## SERVICE BULLETIN #58

SUBJECT: Nose Gear Piston Rod Bearing

APPLICABILITY: Series 5 (Vixen, Voyager), Series 6 and Series 7 Tricycle Gear

Figure 1

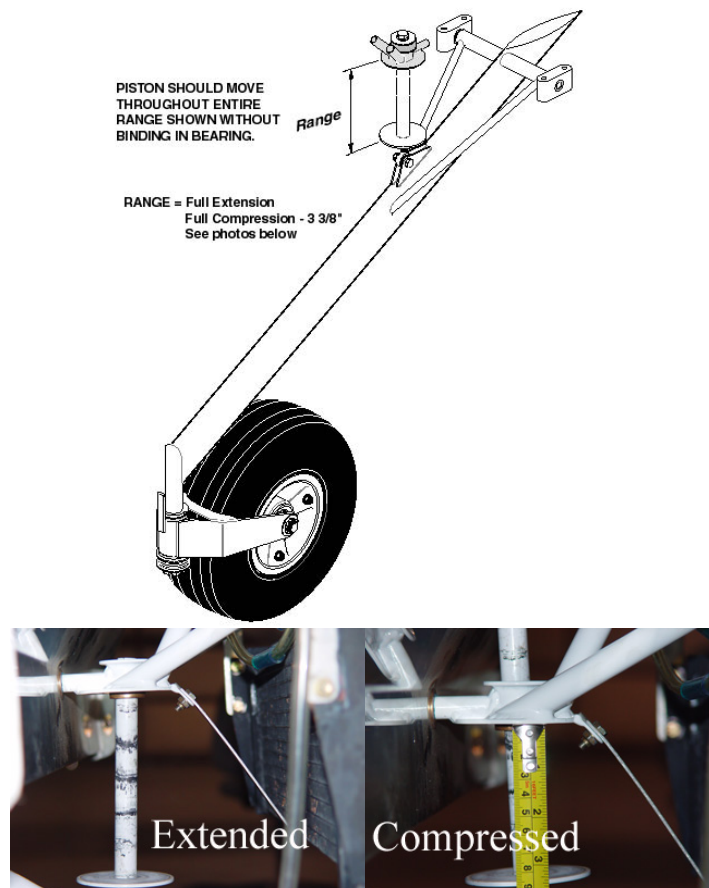
- Without installing the elastomers and friction washers, guide the nose gear piston back into the engine weldment.
- Attach the nose gear piston to the nose gear.
- Using figure 1 as a reference, move the piston & strut assembly through the operating range of the nose gear piston. There should be no binding when the piston is moving in this range. If there is any binding, then additional modification to the piston rod bearing is required per figure 2-1. Continue this process until no binding is present.

Figure 2

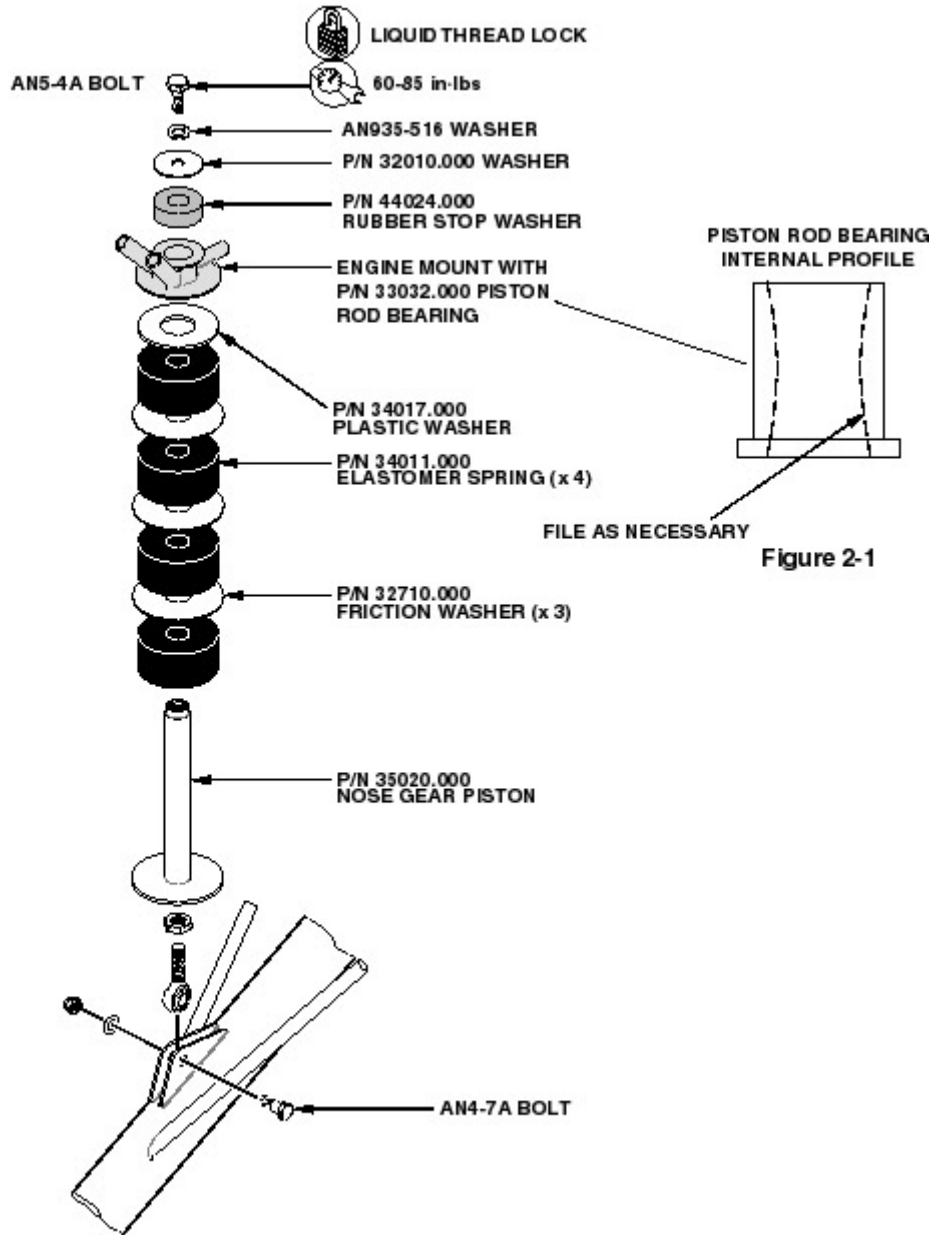
Satisfied the nose gear piston does not bind within its operational range then re-assemble the shock mount per figure 2. Do not forget the liquid thread lock, torque specifications and to grease the rod bearing.
